PLANNING COMMISSION

STAFF REPORT

PLAN-16-1025; NORTHPOINTE DEVELOPMENT CORPORATION

DECEMBER 1, 2016

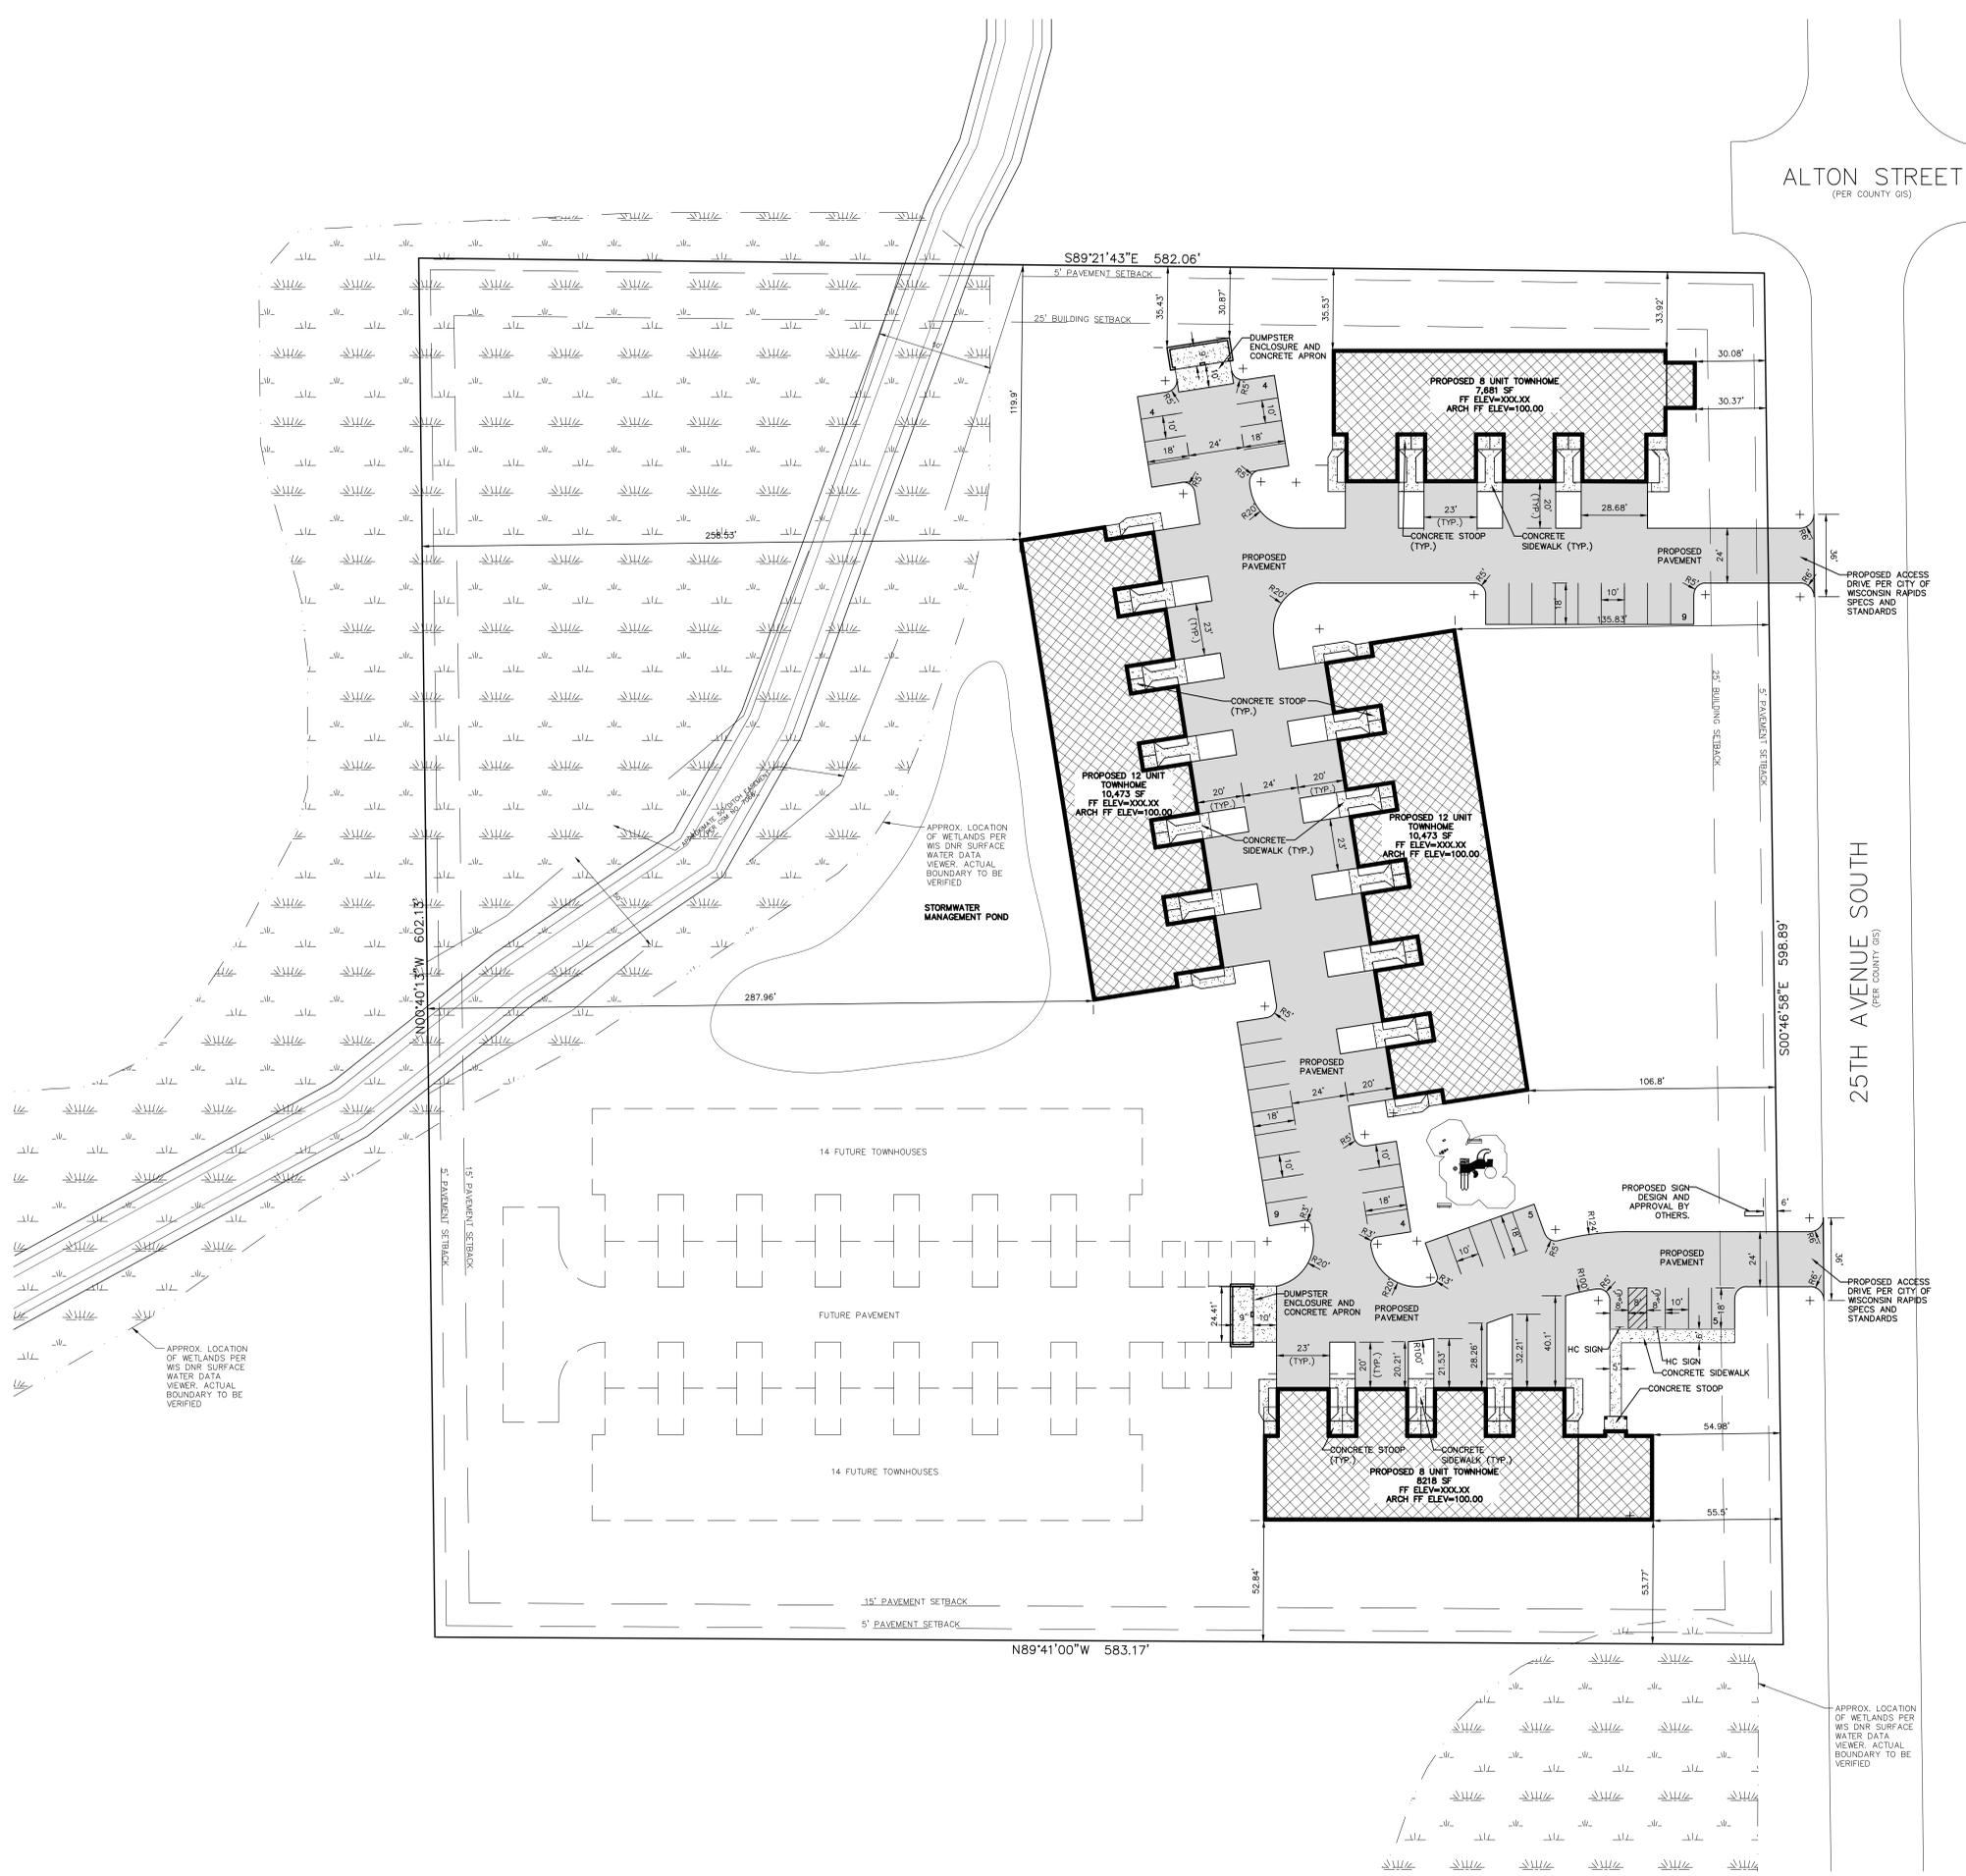
1. Fire protection. It was recommended the private drive be designed to accommodate the aerial truck in case of fire. They also recommended providing a private water main loop to ensure proper water pressure and quantity.
2. Pedestrian Safety and Access. It was recommended that required sidewalks be installed along 25th Avenue South as part of the development. Sidewalks would also be required if/when Alton and 27th Avenue South are constructed.
3. Building and Site Design. It was recommended that the exterior materials on the building not utilize vinyl siding. Instead relying on masonry materials. Landscaping should also be implemented to provide screening from adjacent properties and of garbage and utility areas. Signage should be high quality and appropriate for a residential development.

Within the R-2 district, the maximum building lot coverage allowed is 30%. The proposed layout would be around 21%. The additional hard surfaced areas would cover approximately 13%. The amount of land that would be disturbed is over an acre, which means that the development is subject to the DNR's and City's storm water regulations. The intent at this time is to capture the run-off from the site in one newly created storm water pond. If the project is approved, final engineering will be completed to determine the final solution to meeting the storm water requirements. A large portion of the property will be set aside to remain in the wooded and wetland states that currently exist on site.

Properly sized water and sewer lines exist within the right-of-way of 25th Avenue South. It is recommended that an internal water and sewer system be installed and be connected to the existing City system. To maintain adequate water pressure, the water system is intended to loop along the private drive and reconnect to the City system. Although the proposed density is higher than what is permitted under the R-2 district; staff has stated they feel the proposed development will not pose an undue burden on the public safety services of the City.

1. The subject property shall be developed in substantial conformance with the site and building plans submitted by Excel Engineering dated November 10, 2016.

2. Landscaping shown for each building on the landscape plan, by Excel Engineering dated November 10, 2016, shall be installed prior to the issuance of an occupancy permit for each building on-site. Additional landscaping shall be provided to further screen the dumpster areas and maintain a visual screen along the southern property line. Where possible, existing vegetation shall be preserved.

5. Trash enclosures of similar building materials to the primary buildings shall be constructed to contain all dumpsters on site.
6. Sidewalks shall be installed along 25th Avenue South at the time of development of the subject property. Sidewalks along Alton Street and 27th Avenue South shall be installed at the time of the construction of the public streets.

7. The private access drive shall be designed to accommodate necessary fire department equipment with a minimum turning radius of 53 feet.
8. Water and sewer services shall connect to private mains installed at the developer's expense. Fire hydrants shall be installed as required by the Fire
